UNITED STATES PATENT AND TRADEMARK OFFICE

10/646,611

Office Action Summary	Application No.	Applicant(s)	
	10/646,611	DAWSON, GUY SIMON	
	Examiner	Art Unit	
	Vinh T. Luong	3682

ATTACHMENT

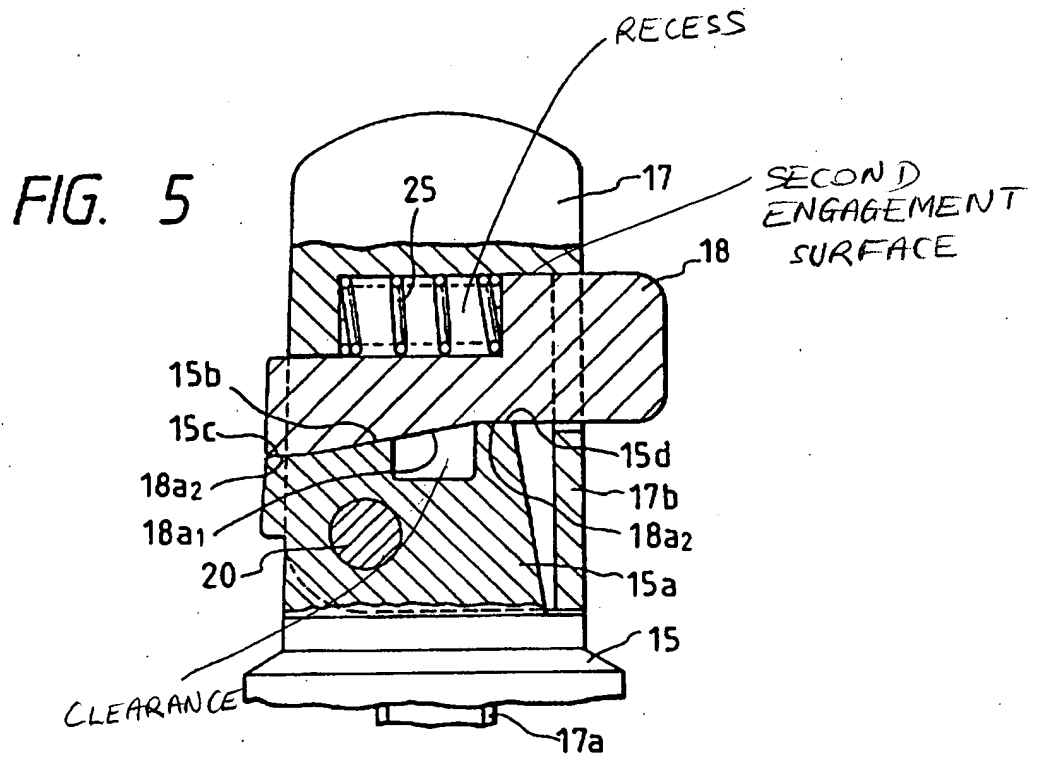
Regarding claim 2, the push button 18 includes a head 18c slidably located in a recess (see Attachment) in the handle member 17.

Regarding claim 3, the peripheral shape of the recess (Att.) substantially corresponds to a peripheral shape of the button 18.

Regarding claim 13, the recess (Att.) includes a contact surface (Att.), which is contacted by the head 18c when the locking member 18 is in the release position.

Regarding claim 18, the lip 18a₂ projects from the blocking portion 18b, 18a₂ (Fig. 4), 18f (Fig. 8A-8C), *etc.* The engagement surface (Att., Fig. 4) is formed by a wall in the handle member 17. The wall (Att.) further forms a second engagement surface (Att., Fig. 5). The blocking portion 18b, 18a₂ (Fig. 4), 18f (Fig. 8A-8C), *etc.* of the locking member 18 is located between second engagement surface (Att., Fig. 5) and a surface 15b of the pivot base 15 to create the blocking action.

FIG. 8A

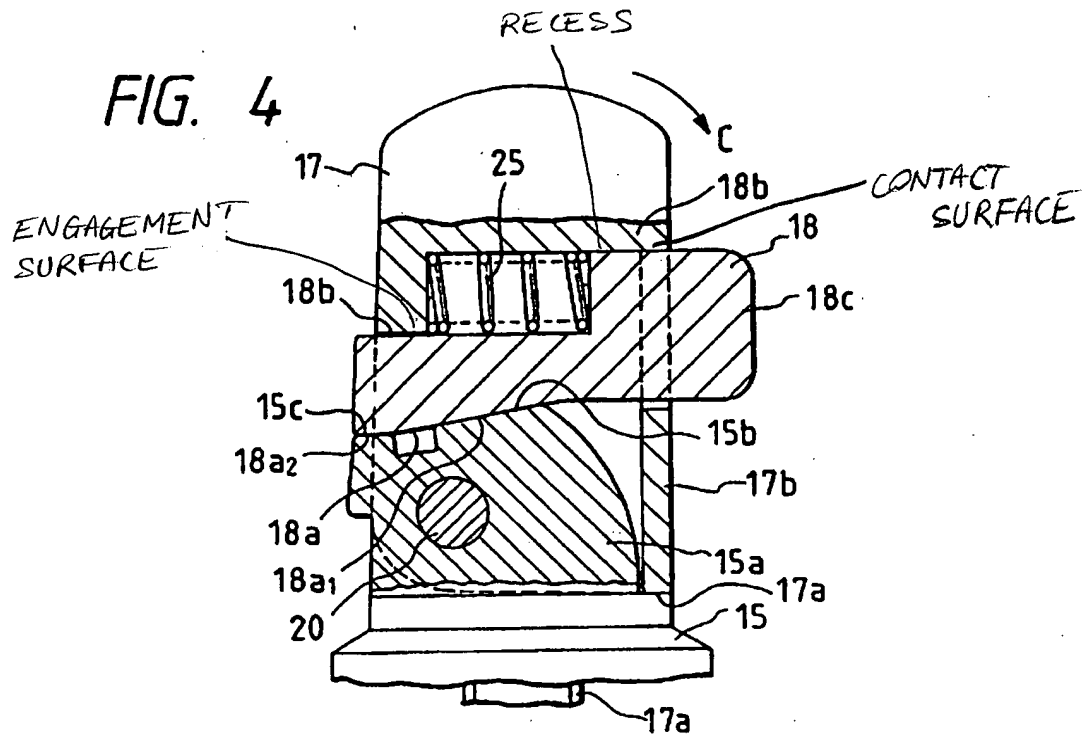
being applied to the handle member 17, the locking mechanism including a locking member 18 slidably engaged through the handle member 17 and able to move between a locking position and a release position (Figs. 1-22), the locking member 18 being coupled to a push button 18 located at an exterior surface of the handle member 17, the locking mechanism having a blocking portion 18b, 18a₂ (Fig. 4), 18f (Fig. 8A-8C), *etc.* located within the handle 17 and positioned between and in contact with opposed surfaces, *e.g.*, at 18b in Fig. 4 of the handle member 17 and 15c, 15b (Fig. 4), 15f (Figs. 8A-8C), *etc.* of the base 15 to thereby block any pivoting of the handle member 17 from the first position,

whereby a pushing action applied to the push button 18 causes the locking mechanism to move to the release position to remove the blocking action of the blocking portion 18b, 18a₂ (Fig. 4), 18f (Fig. 8A-8C), *etc.* See Yamaguchi's claims 1-16.

Regarding claim 8, the stop 18a₂ is a lip 18a₂ projecting from the locking member 25 and engaged with an engagement surface (at 18b in Fig. 4) of the handle member 17 when the handle 17 is in the first position (Fig. 8A).

Regarding claim 10, the locking member 18 includes a profiled portion 18a₁ (Fig. 5), 18e (Fig. 8C), etc. which provides a clearance (Att.) between the locking portion and the pivot base 15 when the locking member 18 is in the release position (Fig. 8C).

FIG. 8C

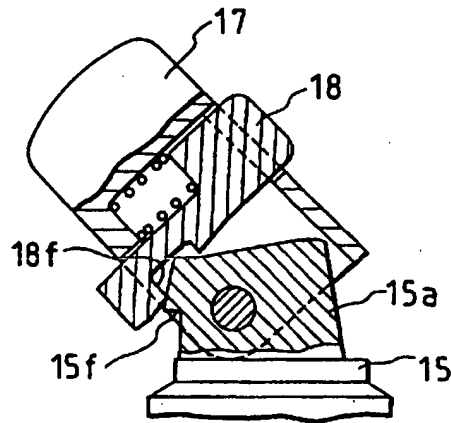
Regarding claim 11, the profiled portion 18a₁ (Fig. 5), 18e (Fig. 8C), etc. includes a contact surface 18a₁ (Fig. 5), 18e (Fig. 8C), which contacts a profiled surface 15b of the pivot base 15 during movement of the handle 17 between the first and second positions.
